**RE: DECK DESIGN
2826 SW HEARTHSTONE PLACE
LEE'S SUMMIT, MISSOURI**

JOB #2025-2443

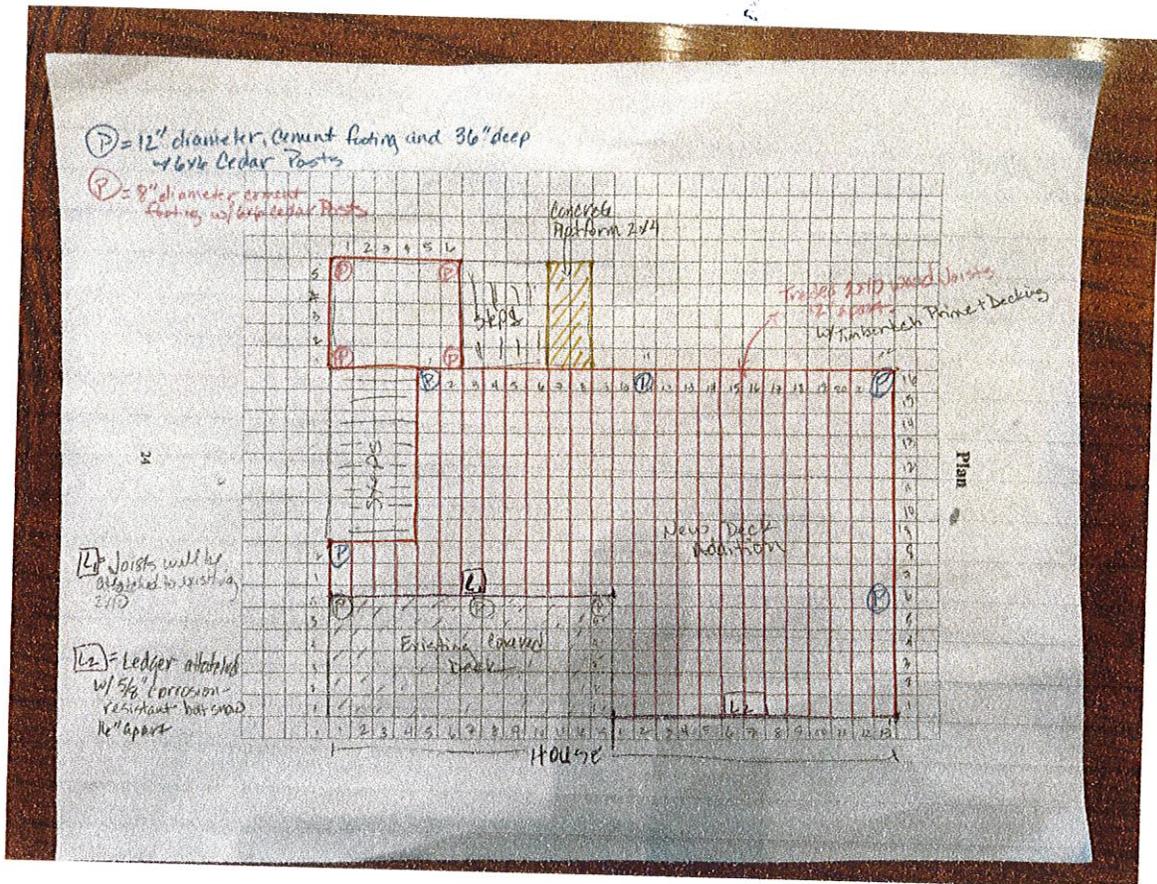
L₁ - Joist attached to existing 2x10 with Simpson Joist hangers

L₂ = ledger attached to rim Joist w/ ledger lock fasteners, 2 rows with a max spacing of 9" horizontally per deck guidelines.
use 1/2" spacers between ledger board & exterior siding of the house.

All Joists to be 2x10's spaced at 12" on center & attached with Joist hangers.

The existing deck at the rear of the house had 3 posts (6x6's) at approximately 6.5 feet on center along the west side of the deck. According to the contractor the piers supporting the posts were 24" in diameter (see attached photograph). In order to reduce the additional load to the posts, I recommend that an additional interior beam be added at the top of the stairs and run across the length of the existing deck (see attached sketch). I have also upsized the pier diameters of the two pier types, flush beams, and ledger attachments to the existing house to be consistent with the Johnson County Deck guidelines, per the Lee's Summit deck permit guidelines indicated on the website.

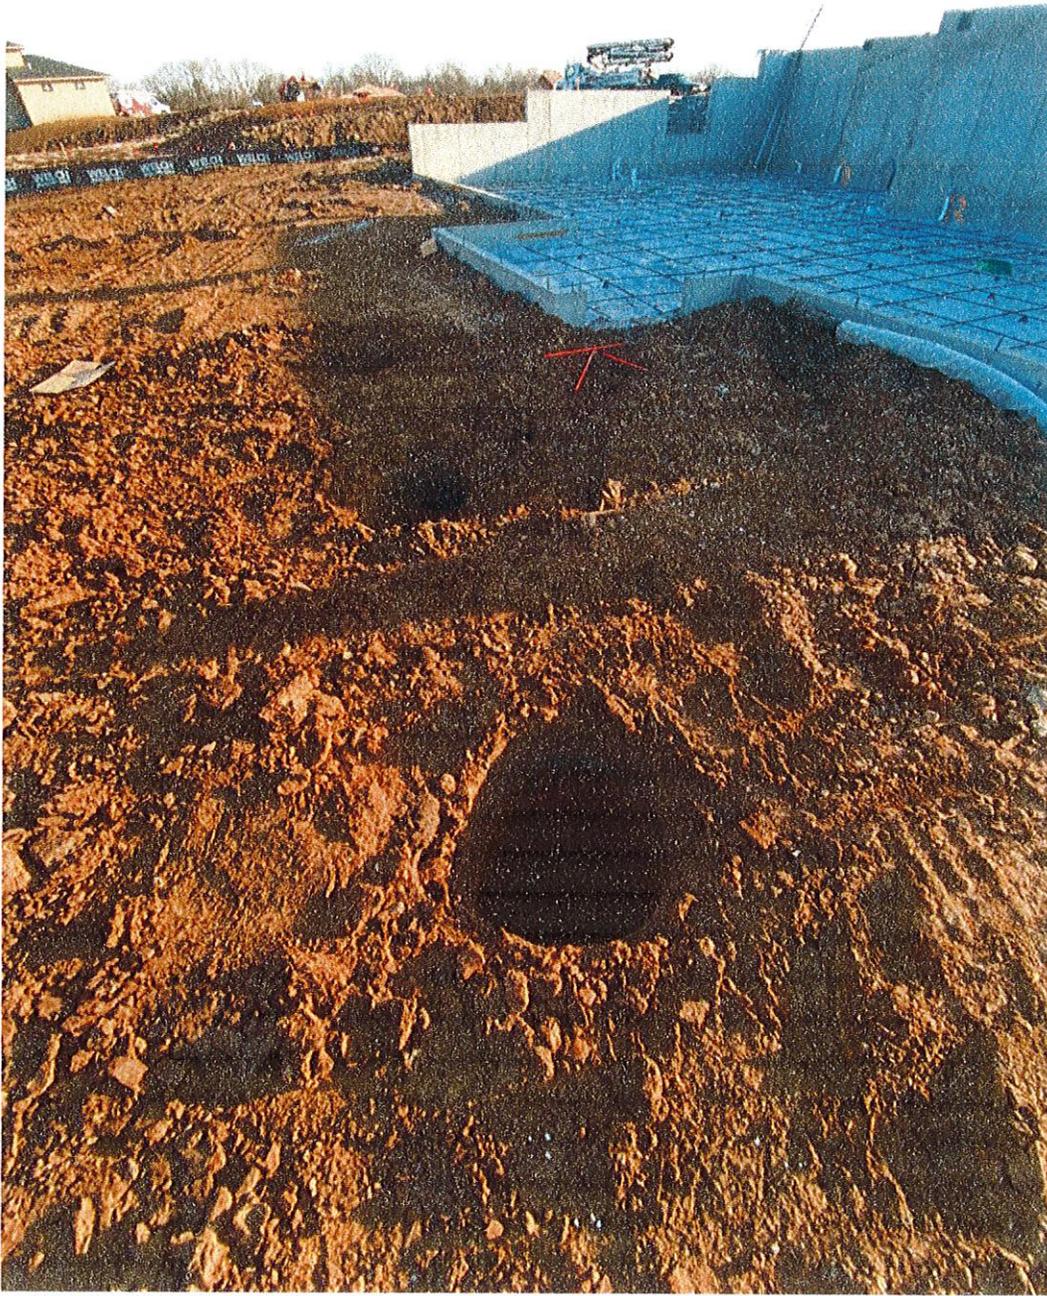
It's great to hear from you! Your (3) deck piers were roughly 24" in diameter (x) roughly 36"-48" deep. They were drilled and then inspected by the engineer, before placement. Here is a picture from the day they were poured. I hope this helps!
